ADDENDUM

Project Name:	Hamtramck Public Schools Window Replacements Phase 1	Addendum No:	Two (2)
Project Number:	21-155	Issue Date:	October 4, 2022
Project Location:	Hamtramck, Michigan

SHEET NO.
 A0-04

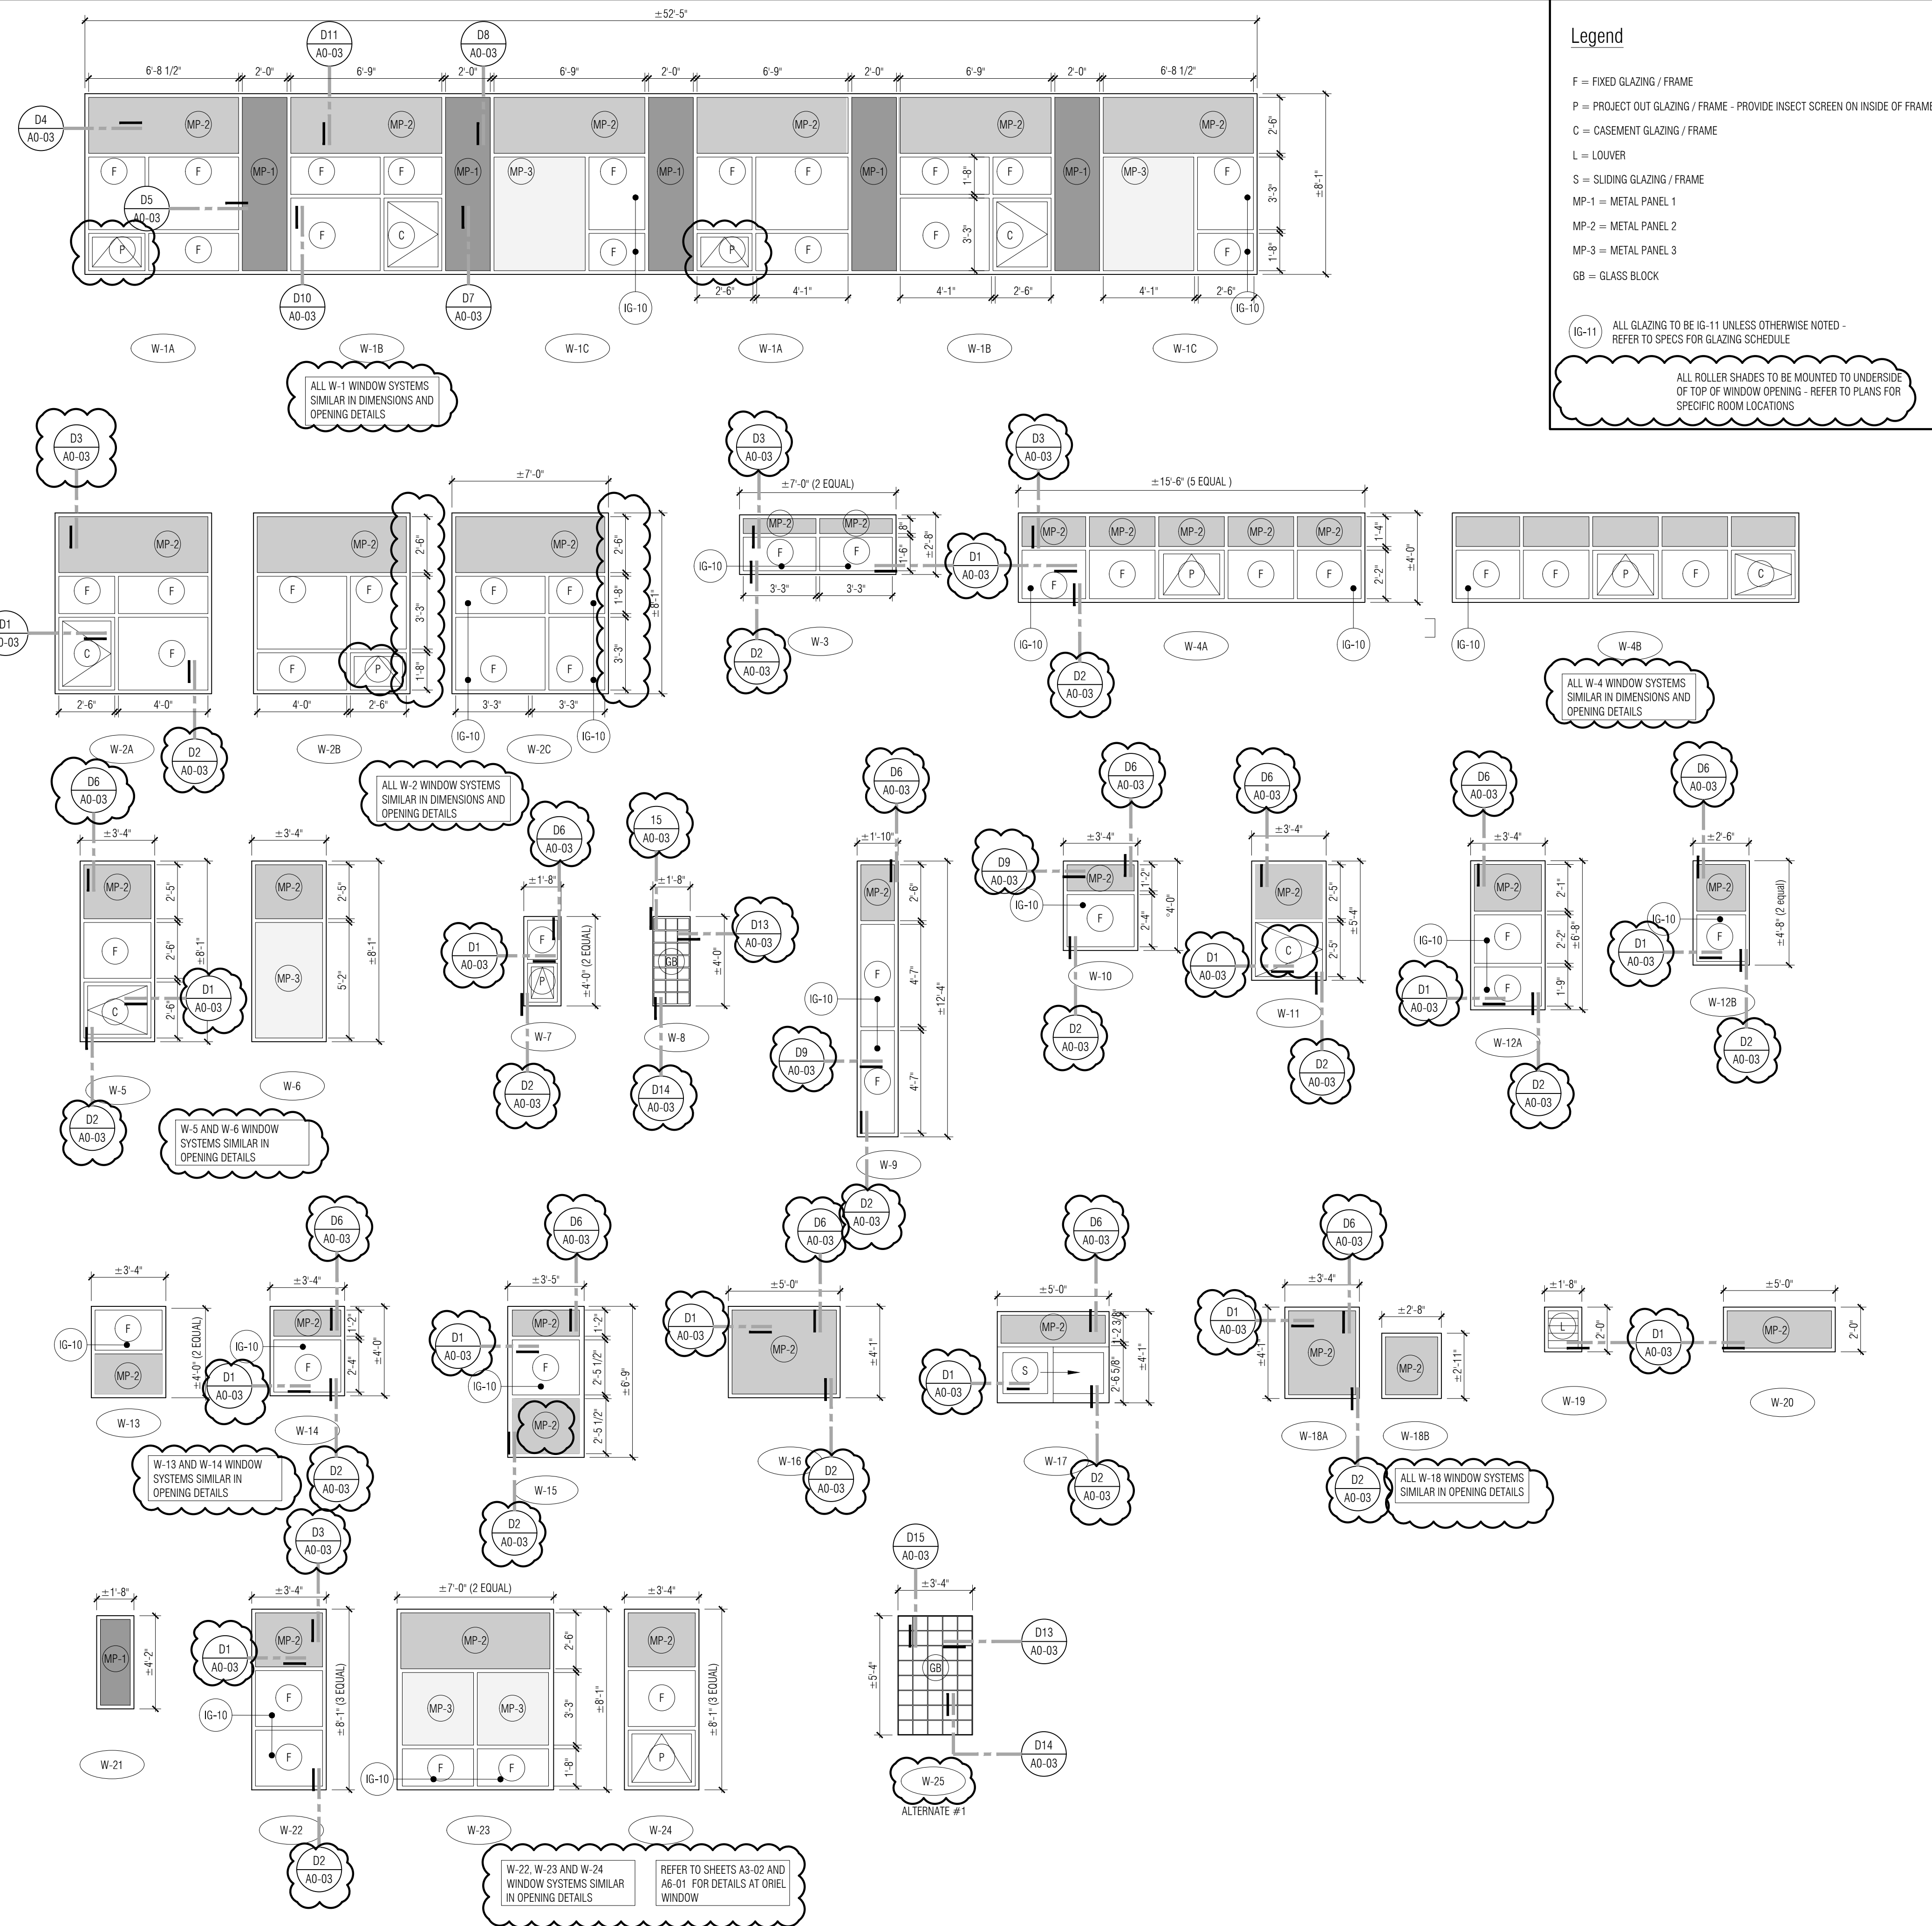
- Item A1** Drawing A0-04; WINDOW INFORMATION (re-issued)
 - A. Detail tags added for opening details.
 - B. Scope clarifications.
- Item A2** Drawing A0-03; OPENING DETAILS (re-issued)
 - A. Scope clarifications.
- Item A3** Drawing A3-01; LOWER LEVEL FLOOR PLAN (revised but not re-issued)
 - A. Add key note #12 to read: NEW STOREFRONT SYSTEM IN MODIFIED OPENING – REFER TO WINDOW SCHEDULE AND DETAIL 6/A6-01.
 - B. Revise key note at openings W-19 and W-20 to be key note #12.
- Item A4** Drawing A3-02; MAIN LEVEL FLOOR PLAN (re-issued)
 - A. Add key note #3A.
 - B. Revise key note tags.
 - C. Added key note tags.

4 Section @ New Entry Canopy
 1 1/2" = 1'-0"

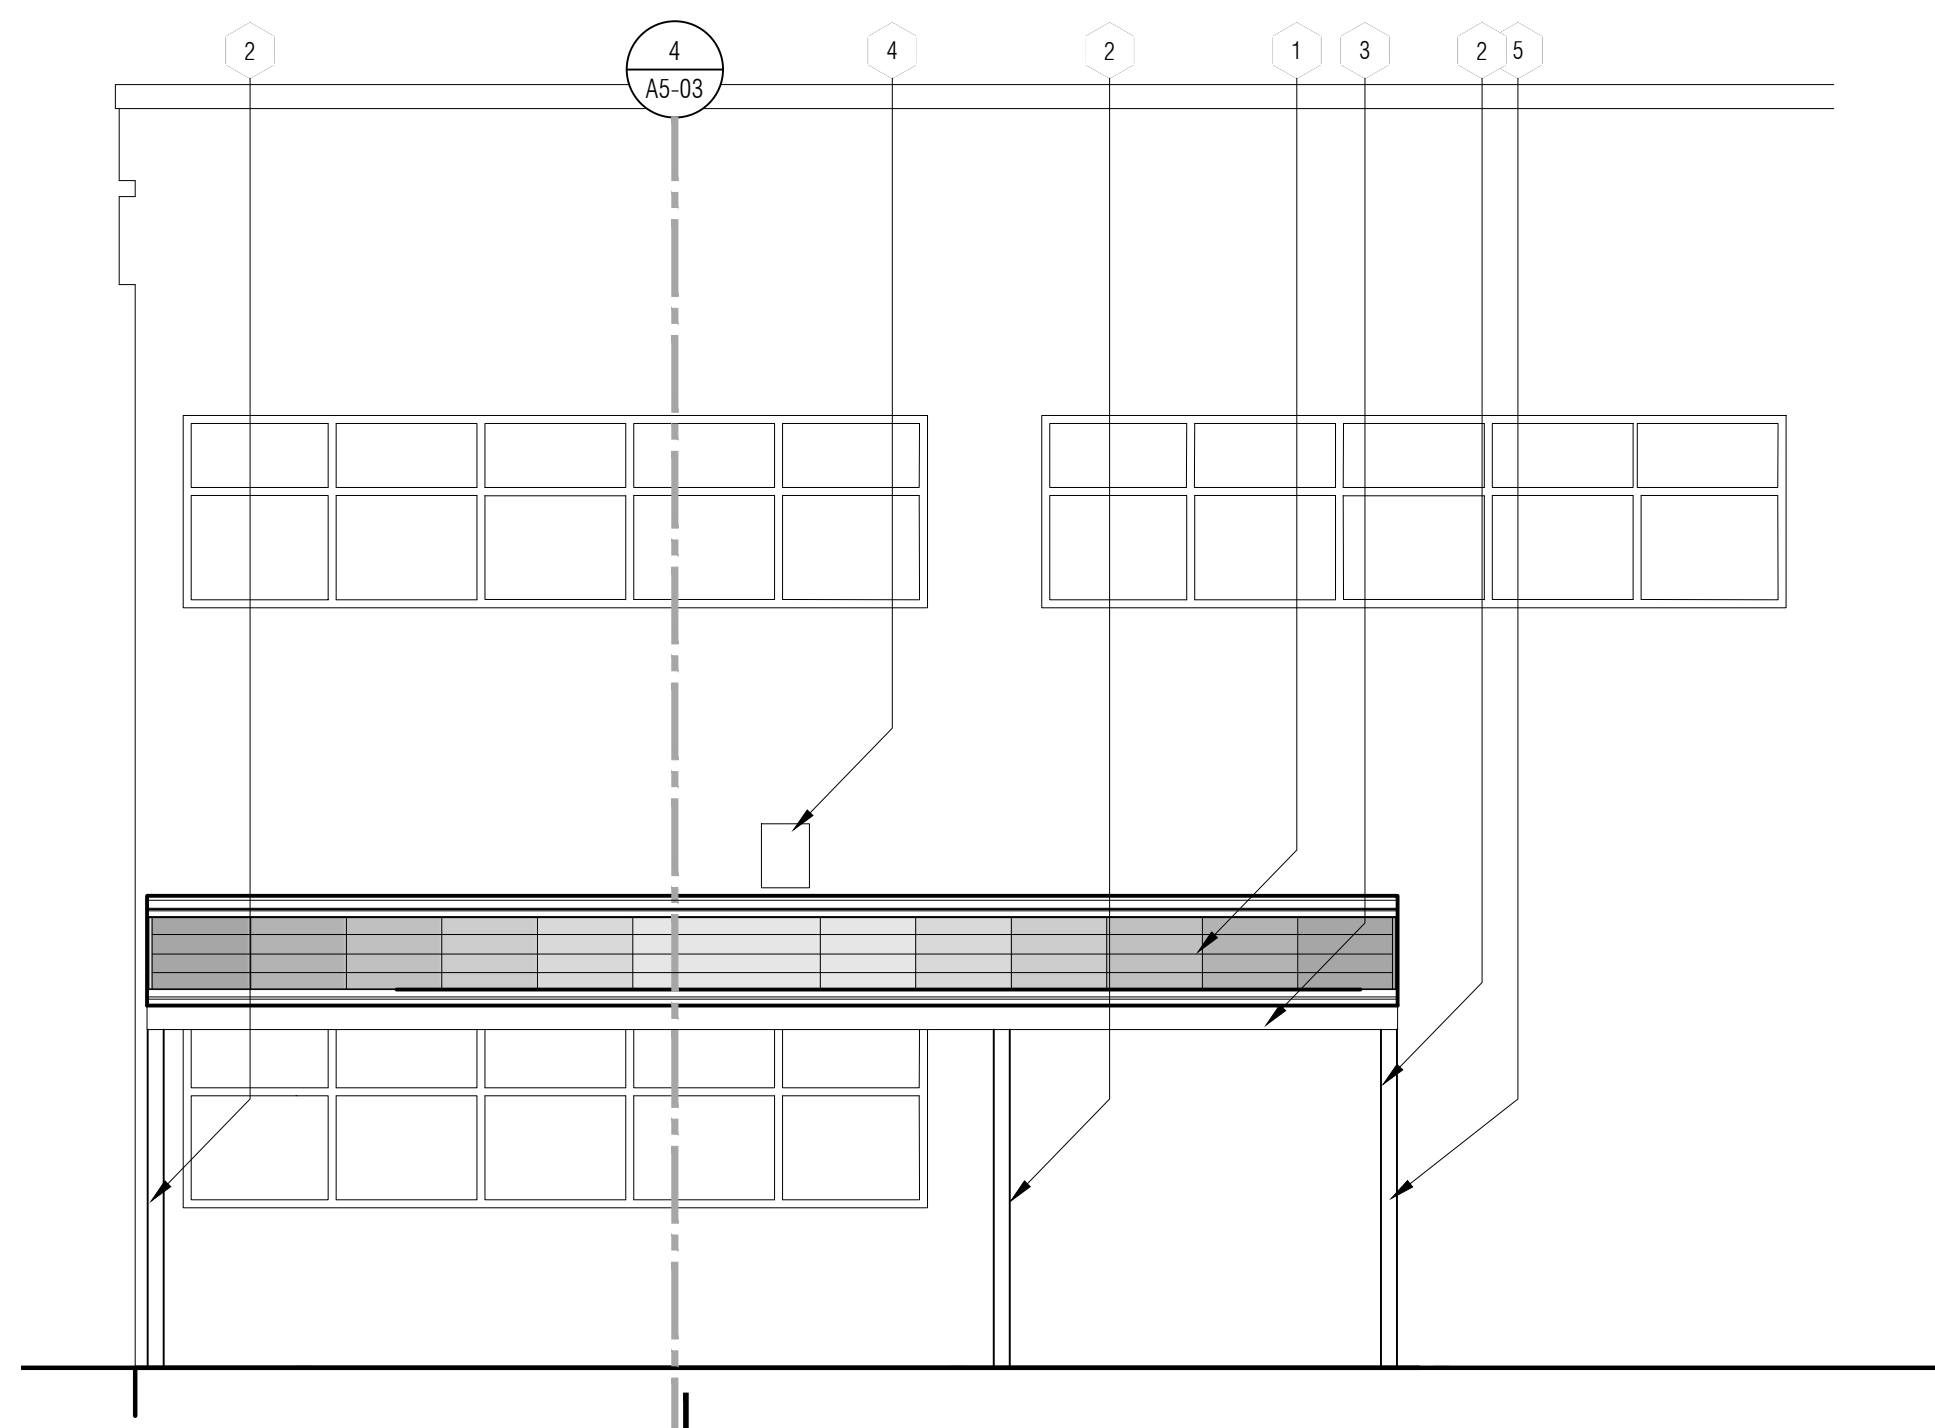
Item A6 Drawing A5-03; CANOPY EXTERIOR ELEVATIONS, ENLARGED PLANS, SECTION DETAILS (re-issued).
A. Revise length of canopy.
B. Add (1) one additional SP-6 panel.
C. Revise Section 4/A5-03.
